**Canyon Fuel Company, LLC**  
Soldier/Dugout Canyon Mine  
P.O. Box 1029  
Wellington, Utah 84542  
(435)637-6360 Fax: (435)636-2897

## APPLICATION FOR COAL PERMIT PROCESSING

**Mine:** Dugout Canyon Mine

**Title:** Sloped Road "Sheet Flow" Design - Chapter 7 and Appendix 7-9

FIGURE 1. RE-GRADING ROAD

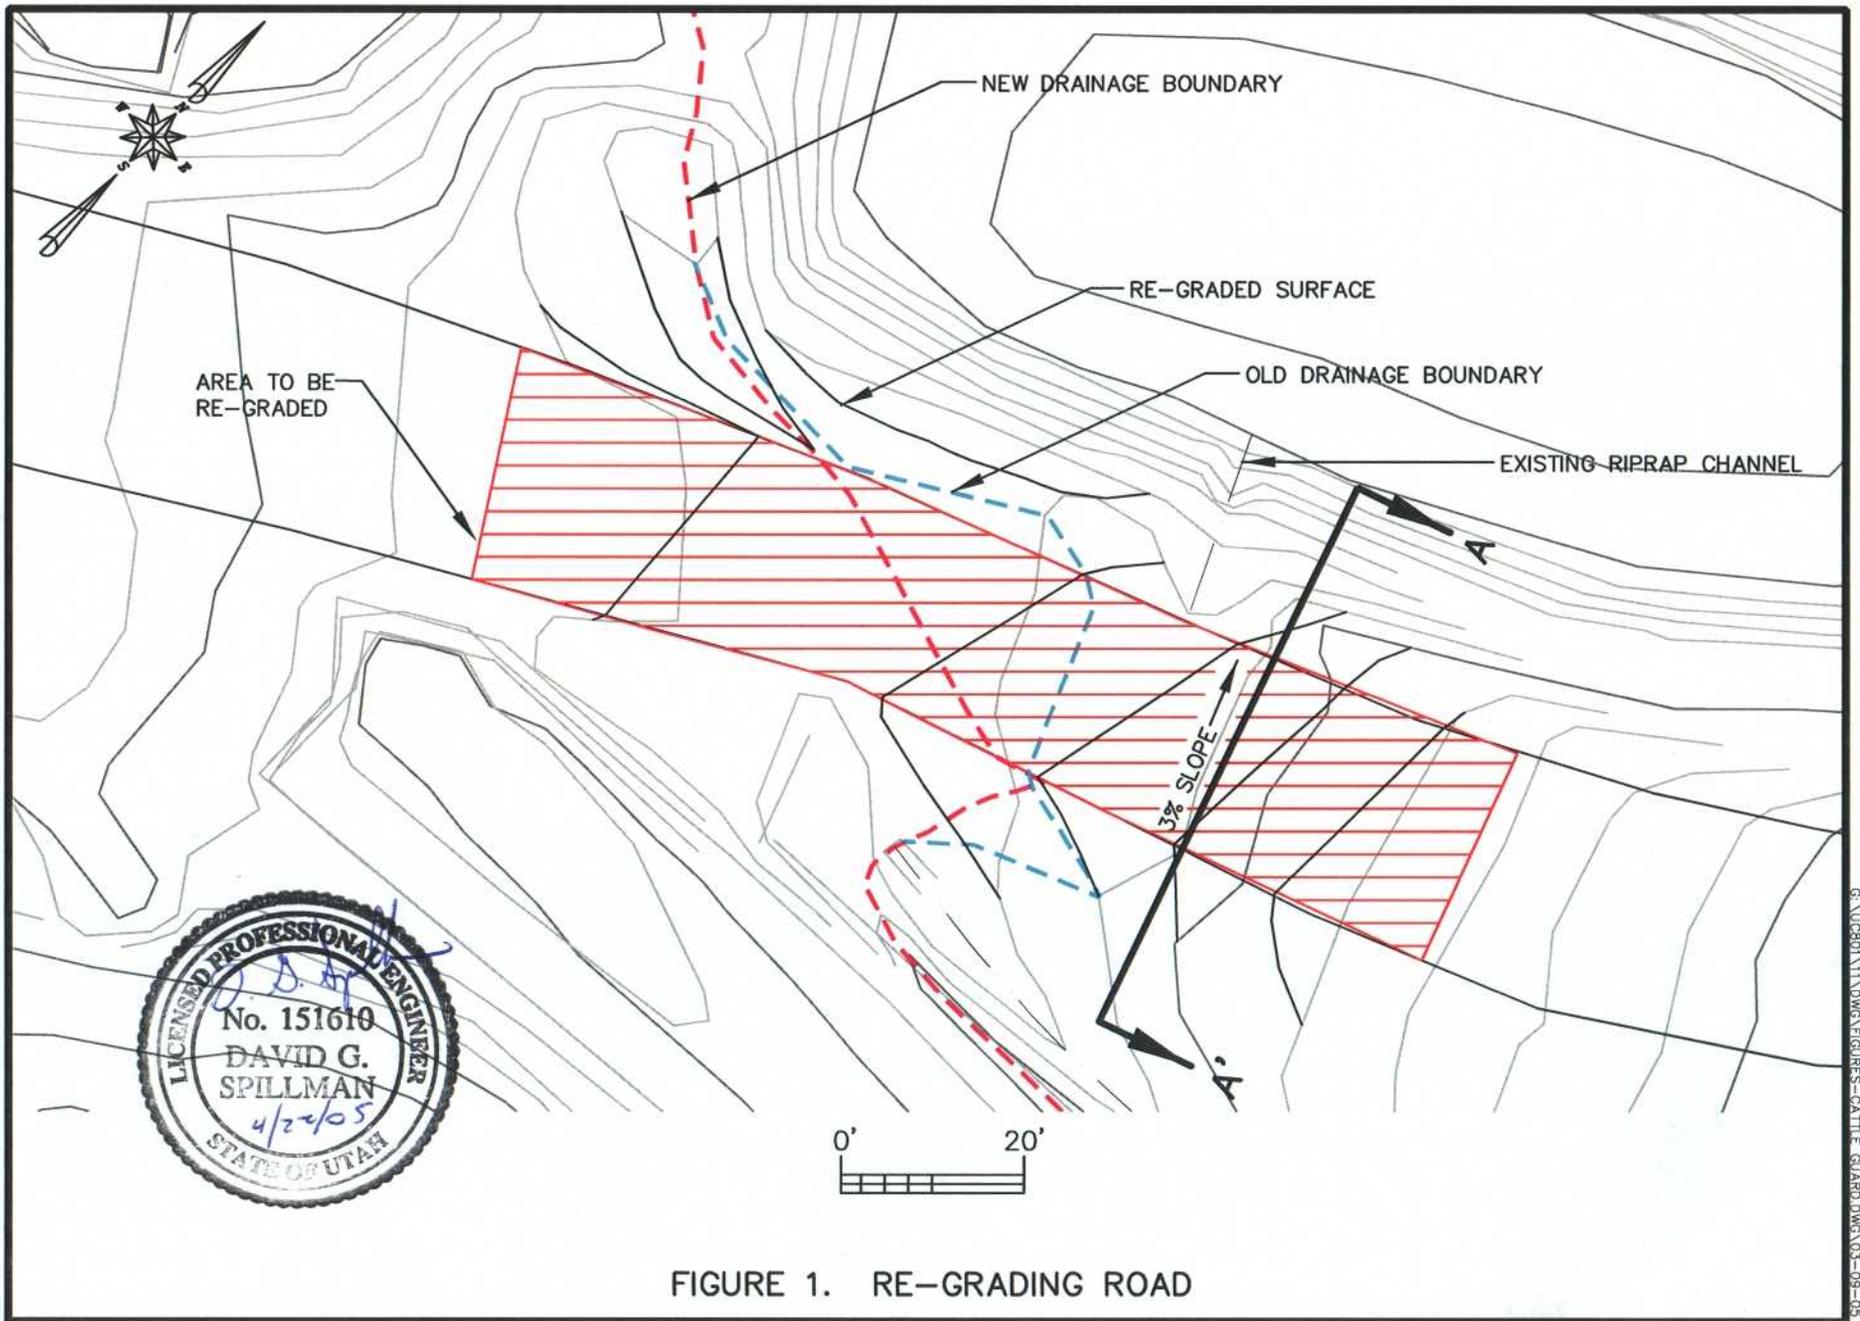
Sloped Road "Sheet Flow" Design - Road Regrading

The Dugout Canyon Mine proposes to replace the swale road crossing discussed in Attachment B to Appendix 7-9 with a road sloping toward the sediment pond. The current road swale is a safety concern and damages the suspension system of the coal haul trucks. To ensure that runoff from the road and adjacent areas that currently report to the sediment pond still reports to the sediment pond, approximately 120 feet of roadway will be rebuilt to slope at 3% towards the pond. Figure 1 in Attachment C to Appendix 7-9 shows the area to be modified as well as the current and proposed drainage boundary. As can be seen on the figure the proposed regraded road section will drain just slightly more of the road to the sediment pond than the current swale.

FIGURE 2. ROAD CROSS-SECTION

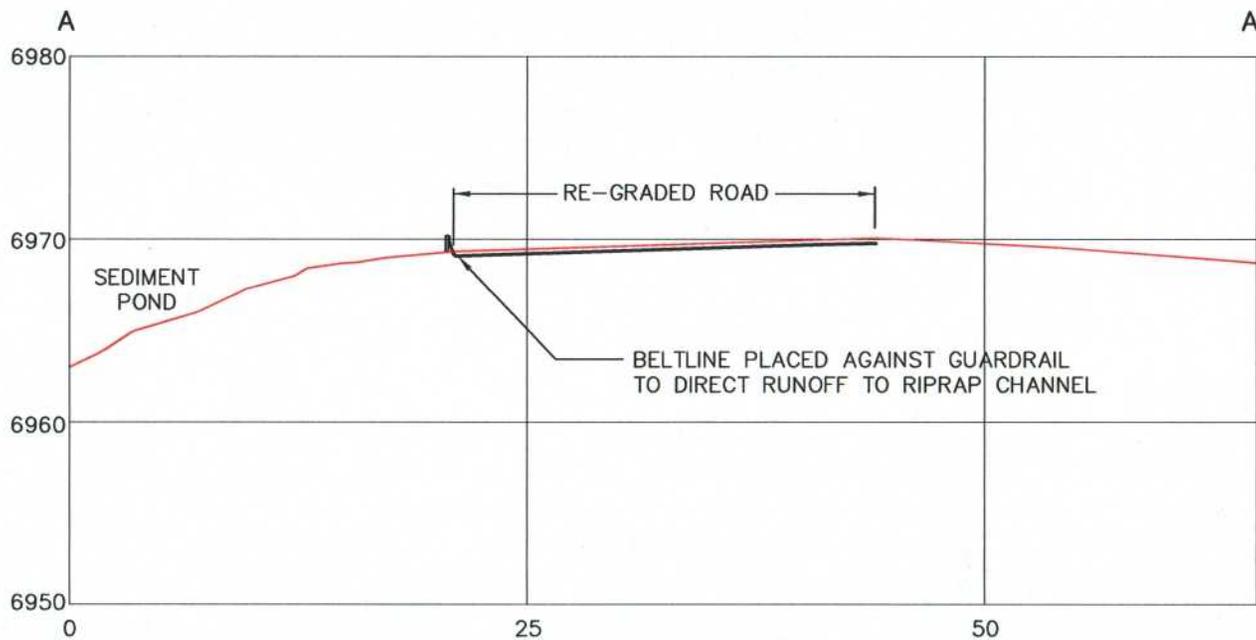
Figure 2 in Attachment C to Appendix 7-9 shows a typical cross-section. The cross-section shows the road sloping at 3% towards the pond and a section of conveyor belting placed against the guardrail to direct road runoff to the existing riprap channel and sediment pond. Please note that a significant portion of the existing road (northeast of the swale) currently is sloped towards the sedimentation pond. The conveyor belting against the guardrail is an existing feature that functions well in directing road drainage towards the riprap channel. This conveyor belting feature will remain intact helping to insure that the road runoff will enter the sediment pond through the riprap channel. A very small amount of road runoff below this point will sheet flow off the road towards the sediment pond and will not require an additional ditch or culvert.

The proposed change to the road will not affect the amount of runoff currently reporting to any existing ditches or culverts. The same amount of runoff directed to the pond by the swale will be directed to the pond by the sloped road.
